Access Compliance Report

Public Rights-of-Way

(Curb Ramps)

Intersection ID: N/A	Main Street: NORTH_COMMUNITY_HOUSE_RD	Cross Street: N/A	Location: N
ADA ID: 1E5978EB4A2E	Ramp Type: PerpDiag	Initial Pass/Fail: Fail	Overall Compliance: No
			Severity Score: 21.25

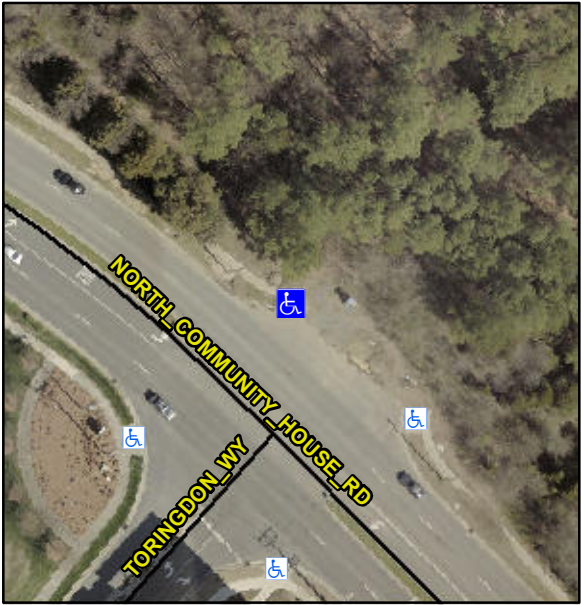
Codes/Mitigation Info/Possible Solution		Field Measurements/Component Compliance					
	Possible Solutions:	Compliance	Description	Data	Compliance	Description	Data
	Remove & Replace Curb Ramp With Two New Directional Ramps or Equivalent.	N/A	Ramp Length (in)	96.0	No	Ramp Slope (%)	8.8
		No	Ramp Width (in)	41.0	Yes	Ramp XSlope (%)	1.6
		N/A	Flare Type LT	N/A	N/A	Flare Type RT	N/A
		N/A	Flare Slope LT (%)	N/A	N/A	Flare Slope RT (%)	N/A
		N/A	Flare Traversable LT?	N/A	N/A	Flare Traversable RT?	N/A
		N/A	Landing Length (in)	N/A	N/A	DWS Provided?	N/A
		N/A	Landing Width (in)	N/A	N/A	DWS Contrast?	N/A
		N/A	Landing Slope (%)	N/A	N/A	DWS Length (in)	N/A
		N/A	Landing X Slope (%)	N/A	N/A	DWS Full Width?	N/A
		N/A	Landing Curb? (Y/N)	N/A	N/A	DWS Offset (in)	N/A
		N/A	Shared Landing?	N/A			
		N/A	Gutter Ponding?	N/A	N/A	Gutter Slope (%)	N/A
		N/A	Gutter Lip Ht (in)	N/A	N/A	Gutter X Slope (%)	N/A
		N/A	Painted X Walk1?	No	N/A	Painted X Walk2?	No

X Walk 1 Direction	To SW		X Walk 2 Direction	To SE
		N/A	X Walk 1 Width (in)	N/A	N/A	X Walk 2 Width (in)	N/A
			X Walk 1 Slope (%)	0.8		X Walk 2 Slope (%)	0.0
			X Walk 1 X Slope (%)	0.4		X Walk 2 X Slope (%)	3.0
		N/A	Ramp inside XWalk1?	N/A	N/A	Ramp inside XWalk2?	N/A
<p>Surveyor Notes:</p> <p>N/A</p> <p>PROW/ADA:</p> <p>R304.5.1, R304.2.2</p>			Road Slope (%)	0.5	N/A	Clear Space?	N/A
			Road X Slope (%)	0.3	N/A	Clear Space to XWalk (in)	N/A
<p>Total Cost:</p> <p>\$ 3200.00</p>		N/A	Any Obstructions?	N/A	N/A	Storm Grate/Utility Hazard?	N/A
			Obstruction Type			Storm Grate/Utility Type	
				N/A			N/A
					Yes	Surface Condition? (G/P)	Good
